Change Order

PROJECT *(Name and address)*:
East Middle School-Classroom Addition
130 Merlin's Maze
Biscoe, NC 27209

CHANGE ORDER NUMBER: 002
DATE: 08/25/2017
ARCHITECT'S PROJECT NUMBER: 1548
CONTRACT DATE: 04/05/2017
CONTRACT FOR: General Construction

CHANGE ORDER NUMBER: 003
DATE: 08/29/17

Footing / DCP test area.

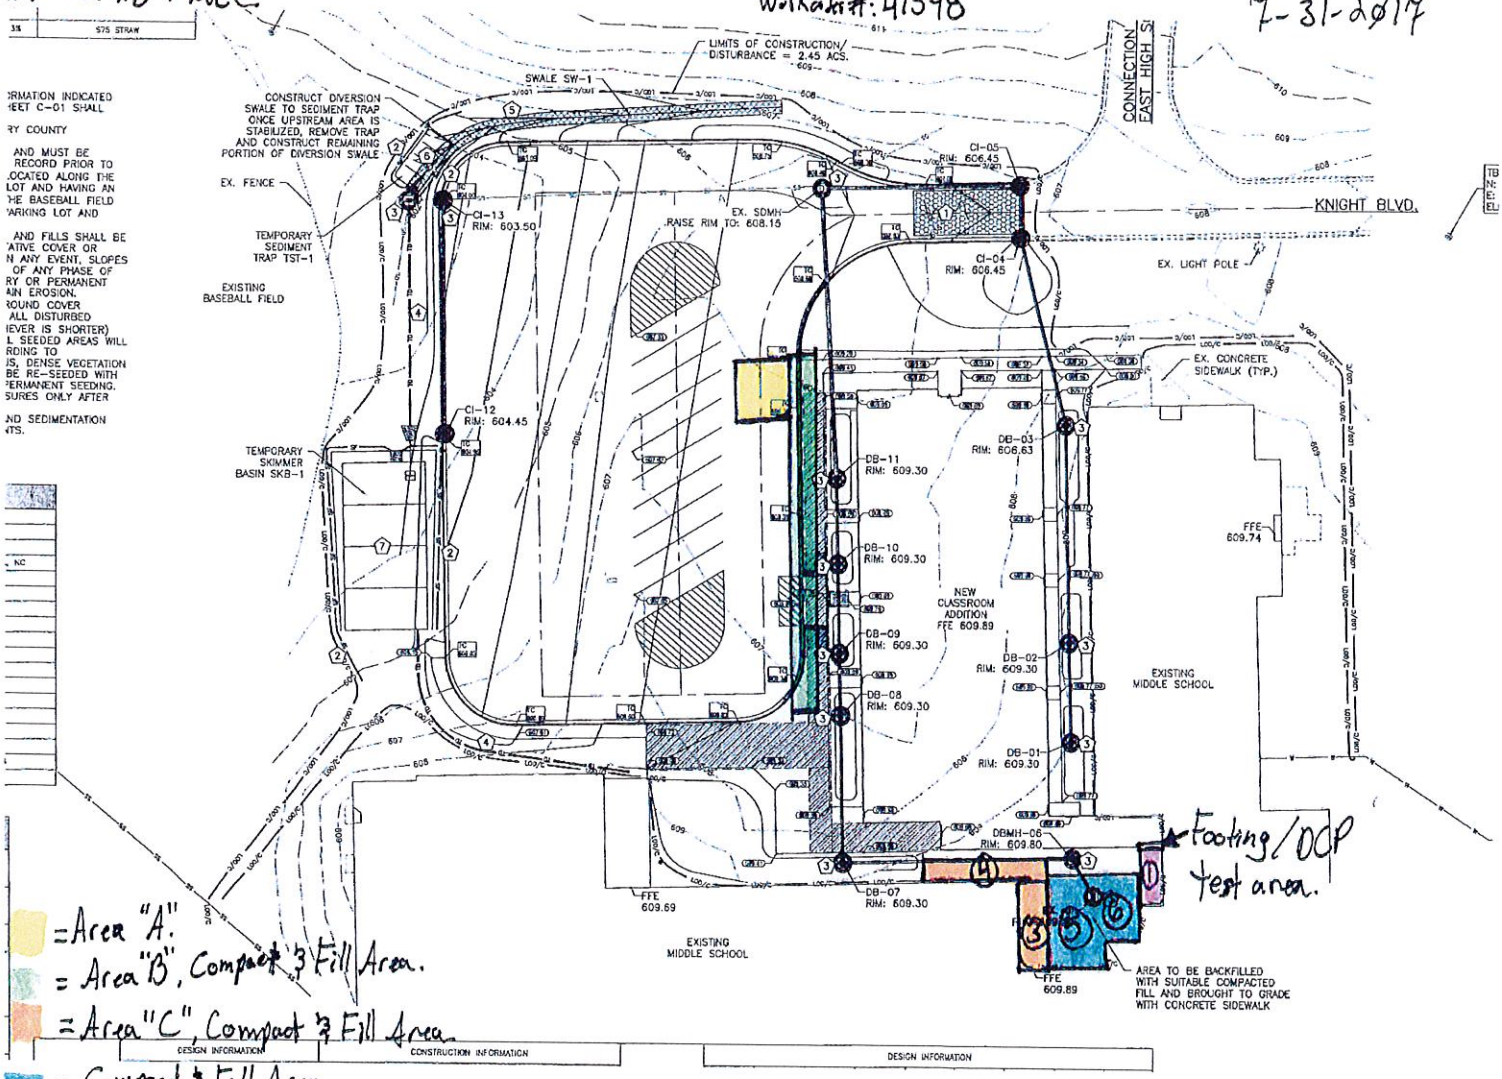
Upon excavation fat clays and silty clays were found. ECS recommendation over excavate FAILING sidewalk areas approximately 12 to 18 inches below finished grade and FAILING parking lot areas approximately 2 foot below finished grade.

Soils quantifications are approximated as follows; Area "A" 67' x 32' x 0.5' = 39.70 cubic yards, Area "B" 247' x 12' x 0.5' = 54.88 cubic yards, Area "C.4" 45' x 6.6' x 1' = 11 cubic yards, Area "C.3" 33' x 14' x 1.5' = 25.66 cubic yards, and Area "D" 13 x 11' x 1.5' = 7.94 cubic yards.

4: The excavation of footing(s): Near hall way connection of existing and proposed buildings. Please see the attached sketch for details on the location ("DCP tetst area").

Utilizing a Dynamic Cone Penetrometer (ASTM STP-399) to check the bearing capacity of soil at the aforementioned location(s), test results indicated that soils, at the areas and elevations tested, should be capable of supporting a foundation designed for a net allowable bearing capacity of 2000 psf respectively.

East Middle School
12of marlins maze.

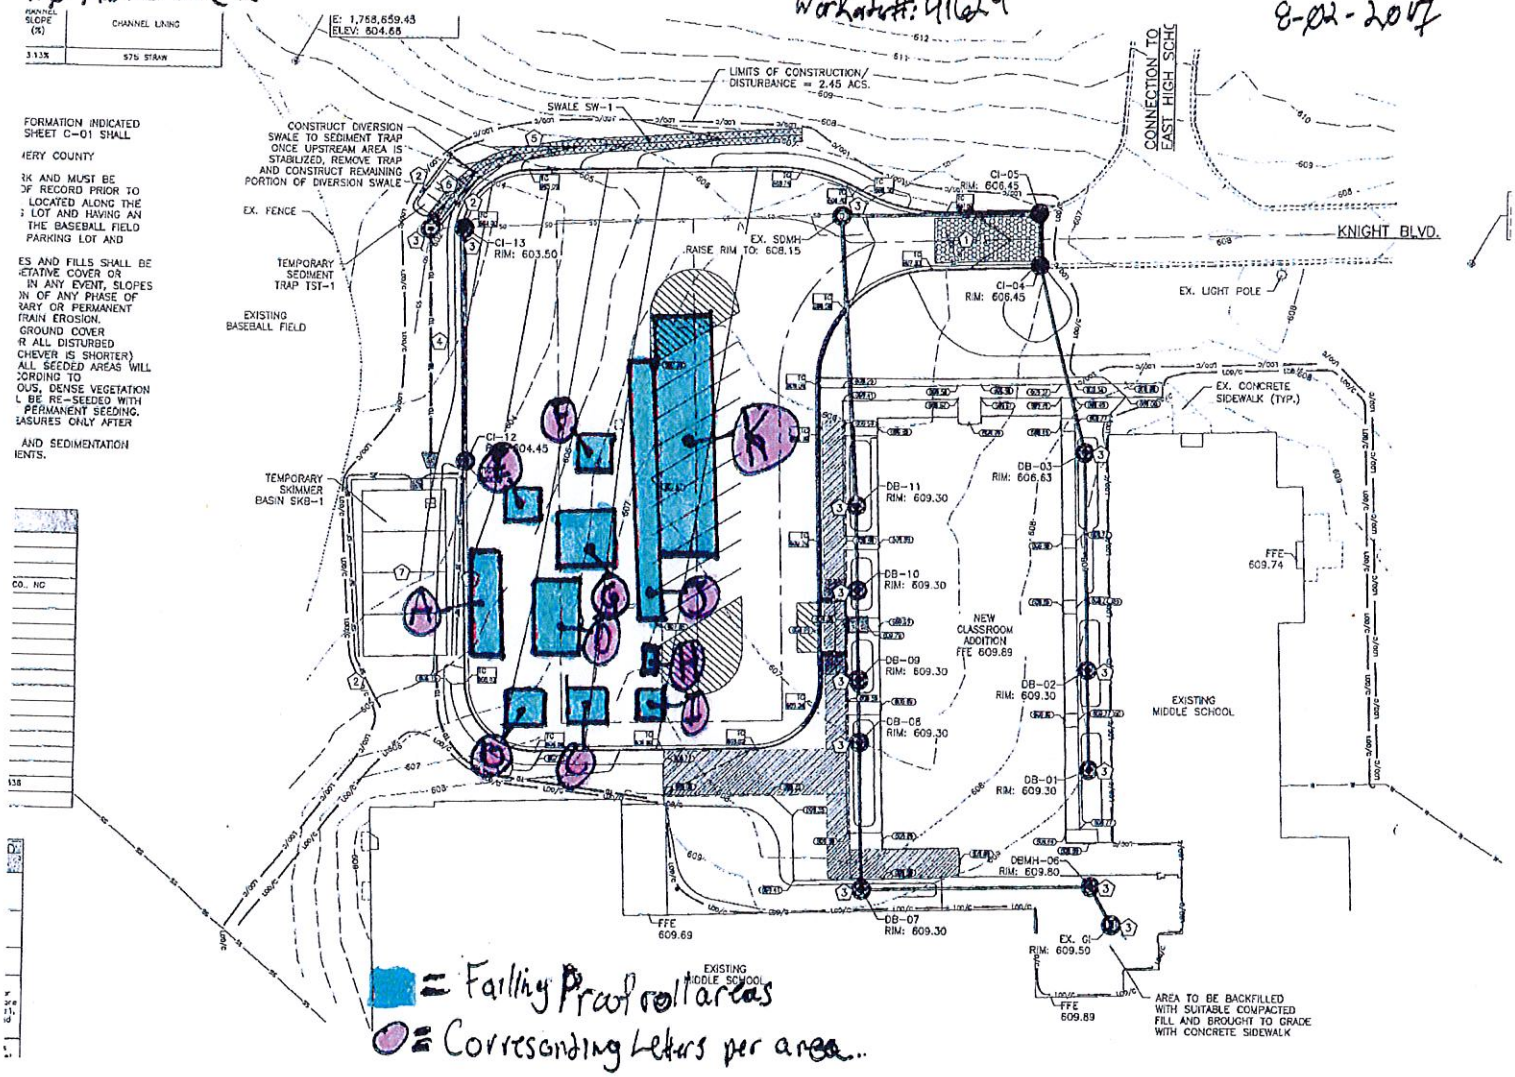
Using a loaded, tandem-axle dump truck, the identified area was proof rolled and visible signs of pumping or rutting was observed in specified areas indicated on sketch. Please note areas indicated on sketch are approximate locations.

ECS recommendation to remove failing soils to depths specified on each failing area. ECS representative was present to observe recommendations preformed in area indicated on sketch.

Soils quantifications are as follows;
Area "A" 28' x 5' x 1' = 5.18 cubic yards,
Area "B" 11' x 7' x 1' = 2.85 cubic yards,
Area "C" 10' x 7' x 1.5' = 3.88 cubic yards,
Area "D" 22' x 21' x 2' = 34.44 cubic yards,
Area "E" 16' x 7' x 1' = 4.15 cubic yards,
Area "F" 13' x 7' x 1' = 3.37 cubic yards,
Area "G" 12' x 5' x 1' = 2.22 cubic yards,
Area "H" 13' x 4' x 1.5' = 2.88 cubic yards,
Area "I" 10' x 10' x 1.5' = 5.55 cubic yards,
Area "J" 90' x 6' x 1.25' = 25 cubic yards,
and Area "K" 72' x 36' x 1' = 96 cubic yards.

NOTE: Quantified soils will be replaced with imported fill (soil).

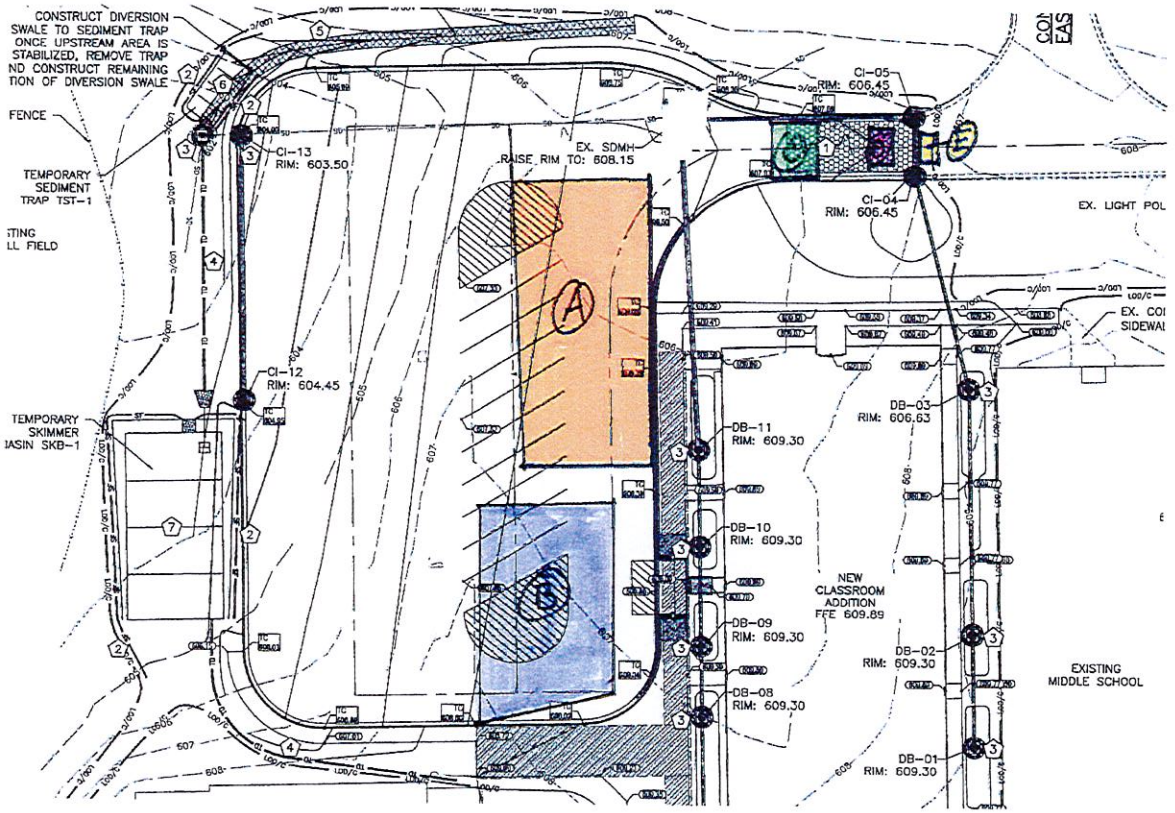
ECS recommendation to remove failing soils to depths specified on each failing area. ECS representative was present to observe recommendations preformed in area indicated on sketch.

NOTE: Quantified soils will be replaced with imported fill (soil).
